INDESIT company

Model type:
WT80FR

Commercial code:
F028669

FIG. 1

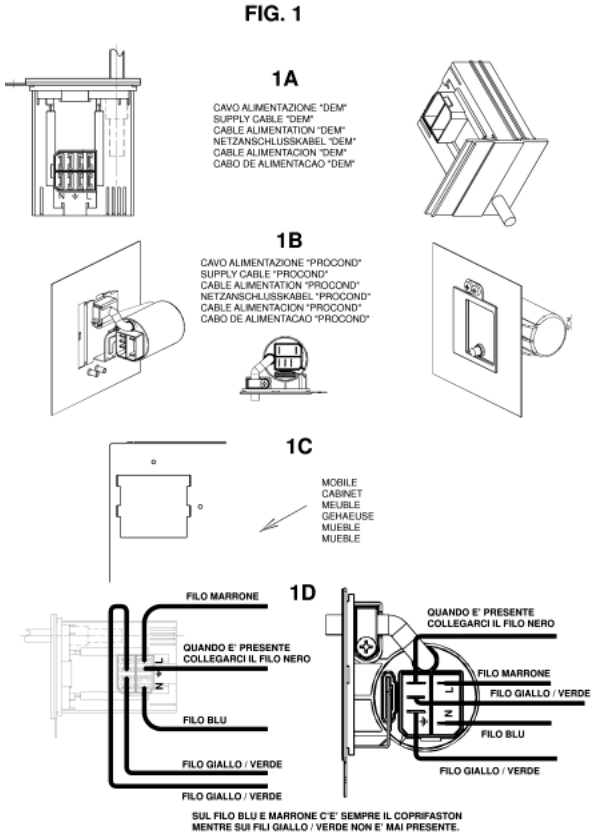
n1040288: Power supply cable + moulded filter on top-load Brembate WMs

From serial number 30224.0001, all top-load washing machines produced in the Brembate factory have been equipped with a new power supply cable with moulded filter and new rear panels with a specific opening for fixing the new cable.

To use premodified wirings on modified products perform the connection to the terminal block of the new cable as shown in fig. 1 - 1D.
The wiring diagrams indicated in the Documentation remain the same.

The new power supply cables are:
Sat code 091632 Power supply cable 3x1 schuko 1.5m+capacitance filter;
Sat code 091633 Power supply cable 3x1 schuko 1.5m+inductive filter;
Sat code 091641 Power supply cable l=2550mm ag +capacitance filter;
Sat code 091635 Power supply cable uk 3x1 l=1950mm+capacitance filter;
Sat code 091634 Power supply cable uk 3x1 l= 1950mm + inductive filter;
Sat code 091689 Power supply cable l=2550mm ag +inductive filter.

The new rear panels are:
Sat code 094067 - premodification Sat code 091893 (used for few months in place of code 083784, see N1040278);
Sat code 094068 - premodification Sat code 093623 (specific for the Hotpoint WMTL80UK model, commercial code 28749).

N1040309FIG1

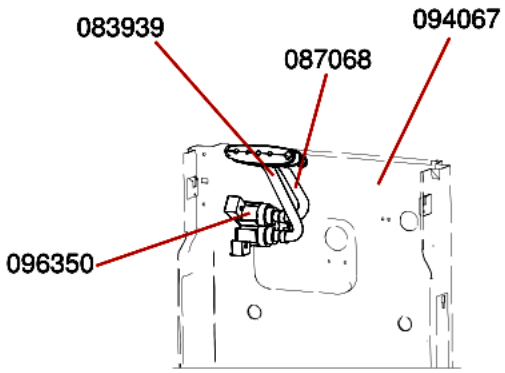
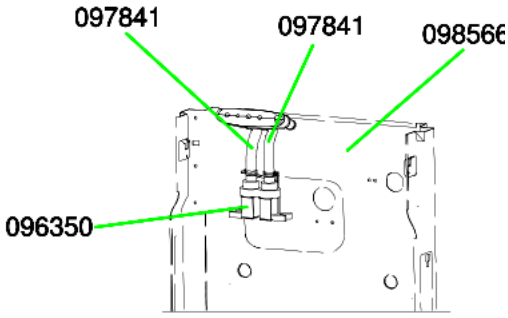
n1040309: Modification of rear panels on TOP LOADING washing machines.

From serial no. 30912.0001, the system used for fixing the loading solenoid valve (spare part code 096350) to the rear panel has been modified on Top Loading washing machines, rotating its position by 90°.
The solenoid valve (spare part code 096350) has been modified with the 45° rotation of a coil; the Replacements Warehouse will continue to manage this part with the same code. When replacing on premodification machines, fit the coils as shown in figure N1040309FIG3-1 and on modified machines, as shown in figure N1040309FIG3-2; to rotate the coil, lift it using a screwdriver and then refit according to the inserts on the plastic.

Replacement codes of the parts affected by this modification (see figure N1040309FIG1):

FIG1 A - PREMODIFICATION STRUCTURE
solenoid valve tube/distributor assembly: premodification 083939;
solenoid valve tube/distributor assembly: premodification 087068;
rear panel: premodification 094067.
FIG1 B - NEW STRUCTURE
solenoid valve tube/distributor assembly: new 097841;
solenoid valve tube/distributor assembly: new 097841;
rear panel: new 098566.

Premodification panels will be managed by the Replacements Warehouse while stocks last; when replacing with new ones on premodification appliances the new tubes must also also be used.

When using the new panels on appliances before serial no. 30609.0001, fitted with solenoid valve code 083940, rotate the coil 45° and follow the instructions given above for code 096350, paying attention during the wiring phase to keep the cables away from the bowl support spring.

N1040309FIG2

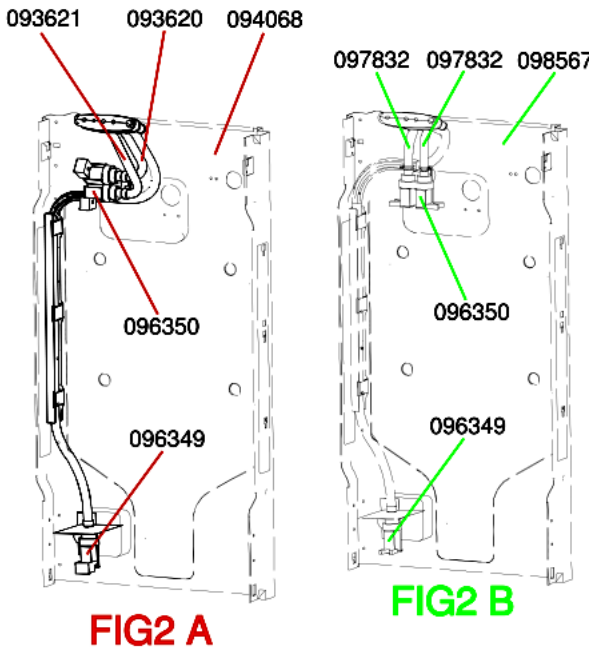
Replacement codes of the parts affected by the modification to WMTL80UK (see figure N1040309FIG2):

FIG2 A - PREMODIFICATION STRUCTURE
solenoid valve tube/distributor assembly: premodification 093620;
solenoid valve tube/distributor assembly: premodification 093621;
rear panel: premodification 094068.
FIG2 B - NEW STRUCTURE
solenoid valve tube/distributor assembly: new 097832;
solenoid valve tube/distributor assembly: new 097832;
rear panel: new 098567.

n1040321: Plastic protecion for solenoid valve.

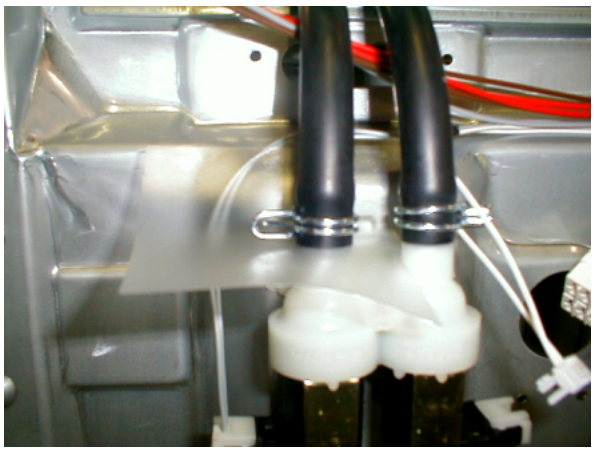
All top-load washing machines produced from September 2003 to February 2004 (from serial no. 30900.0000 to 40300.0000) have been equipped with a plastic protection Service code 109798 (shown in N1040321FIG1), to prevent water from damaging the solenoid valve and electronic card.

N1040324FIG1

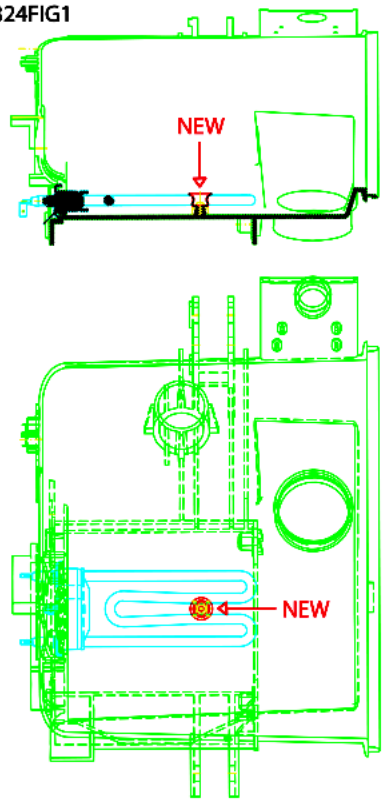
n1040324: Modification of heater fixing system on top-load washing machines.

From serial number 40506.0001, the fixing system of the heater to the tank has been modified on all top-load washing machines affected by this note, with the introduction of a metal retainer (image N1040322FIG1 reference NEW) in place of deflector Service code 055322.

-PLASTIC TANK FOR 600-1000 RPM MACHINES: new 110152, premodification 083805;

-PLASTIC TANK FOR 1200 RPM MACHINES: new 110153, premodification 092023;

-HEATER: new 110148, premodification 083906.

N1040404FIG1

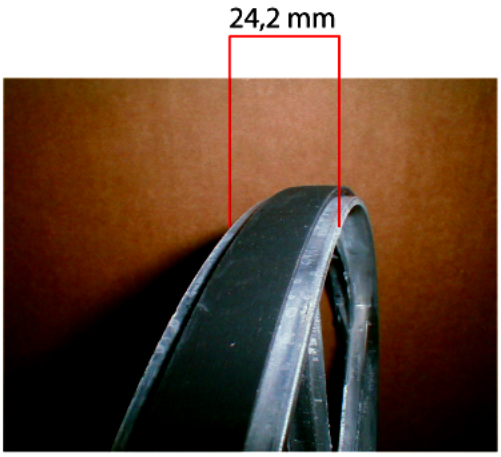
n1040404: New pulley installed on top loading washing machines up to 1000RPM (NO tub lock)

From serial no. 51202.0001 the pulley track has been widened from 21.2mm to 24.2mm (see picture N1040404FIG1).

new pulley
C00142832 - D280 24.2 mm track

Premodification pulley
C00083912 - D280 21.2 mm track

The new pulley can also be used on premodification versions of the models referred to in this release.
